MECKLENBURG COUNTY
DEPARTMENT OF ENVIRONMENTAL HEALTH

APPLICATION FOR SOIL INVESTIGATION

Re: Property located at 13716 Idlefield Lane, Lot PO 36, Blk. C

SITE EVALUATION

**See Diagram on Back (includes: soil areas, property lines, roads, streams, gullies, wet areas, fill areas, wells, water bodies, slopes)

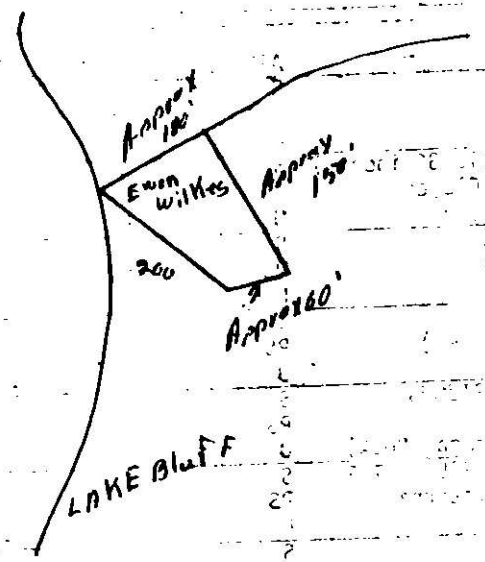
FACTORS	AREA 1	AREA 2	AREA 3	AREA 4
1. SLOPE (%)	(S) PS U 2-6%	S PS U	S PS U	S PS U
2. SOIL TEXTURE (12-36 inches) Sandy, Loamy, Clayey (Note 2-1 Clay)	S PS (U) 2-1 Clay	S PS U	S PS U	S PS U
3. SOIL STRUCTURE (12-36 inches)	S (PS) U weak blocky	S PS U	S PS U	S PS U
4. SOIL DEPTH (inches)	S PS (U) 8-24"	S PS U	S PS U	S PS U
5. RESTRICTIVE HORIZONS (Inches) (Impervious strata, Rock)	S saprolite PS 8-24" (U)	S PS U	S PS U	S PS U
6. SOIL DRAINAGE/GROUNDWATER (external and internal)	S (PS) U ground water 36"	S PS U	S PS U	S PS U
7. OTHER (Specify)	S PS U	S PS U	S PS U	S PS U
8. SOIL GROUP	IVB			
9. SITE CLASSIFICATION	unsuitable			
10. SOIL SERIES	Enon-Wilkes Intergrade

Idle Field
Approx 180'
Ewen Wilkes
Approx 150'
200
Approx 160'
LAKE Bluff
